Staff Report & Recommendation

Historic Preservation Board

SUBJECT: HPB0716-0046, **915, 947 and 955 Washington Avenue – Moxy Hotel**.

915 Washington Avenue - West Elevation Building Permit No. 8343

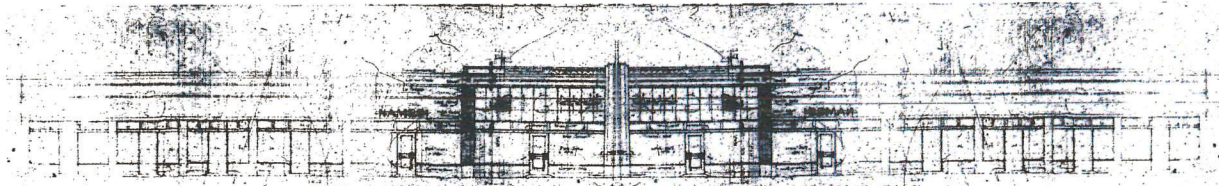
The symmetrical plan for 915 Washington Avenue is characterized by two central bays of equal width flanked by five bays of varying widths to either side. The applicant is proposing reconfigure the façade so that it is no longer symmetrical. The proposed façade consists of three bays to the south and four bays to the north, inconsistent with the original design of the 'Contributing'

building. Consequently, staff would recommend the 5-2-5 façade configuration be retained in a manner consistent with the original building permit plans shown below.

Within the central two bays, the applicant is proposing to setback the storefront windows approximately 3'-0" eastward of the building façade. This will result in at least one 'floating' rectangular column where the existing fluted pilasters are located. Staff believes this condition is highly inconsistent with the original design and would therefore recommend that the storefront glazing, with the exception of the entry doors, not be recessed. Additionally, within this portion of the building, the applicant is proposing to install what appears to be a metal clad awning or concrete eyebrow. Regardless of the proposed material, staff believes that this continuous horizontal element which spans both bays interrupts the vertical emphasis of the center portion of the building. Consequently, staff recommends the elimination of this element.

With regard to the proposed storefront window design, staff would note that it appears from the renderings provided, that the applicant is proposing a semi mirrored glass, dark colored window frames and frameless glass doors. In order to be more consistent with the original design of the building, staff would recommend clear glass windows with the minimum tint to comply with energy codes, clear anodized aluminum, powder coated grey or silver frames and doors with a frame and kick plate. Additionally, after examining the original permit plans, staff believes that all of storefronts contained transom lites, and would recommend the reintroduction of transoms within the storefront windows consistent with the original design shown above.

- b. The 5-2-5 bay configuration of the building at 915 Washington Avenue shall be maintained, in a manner to be reviewed and approved by staff consistent with the Certificate of Appropriateness Criteria and/or the directions from the Board.

- c. The recessed storefront windows of the center two bays of the 915 Washington Avenue building shall not be approved. All storefront glazing, with the exception of the two entry doors, shall be aligned with the exterior face of the west elevation, in a manner to be reviewed and approved by staff consistent with the Certificate of Appropriateness Criteria and/or the directions from the Board. This shall not prohibit entry doors from being recessed.

- d. Transom windows shall be introduced within the storefront windows on the 915 Washington Avenue building consistent with available historical documentation, in a manner to be reviewed and approved by staff consistent with the Certificate of Appropriateness Criteria and/or the directions from the Board.

- e. The scored stucco grid pattern located at the center two bays of the 915 Washington Avenue building shall be reintroduced consistent with available historical documentation, in a manner to be reviewed and approved by staff consistent with the Certificate of Appropriateness Criteria and/or the directions from the Board.

- f. The awning/eyebrow structure located at the center two bays of the 915 Washington Avenue building shall not be permitted.
 - g. All kitchen venting and other venting shall be chased to the roof and venting systems shall be employed as necessary to minimize or dissipate smoke, fumes and odors, in a manner to be reviewed and approved by staff consistent with the Certificate of Appropriateness Criteria and/or the directions from the Board.
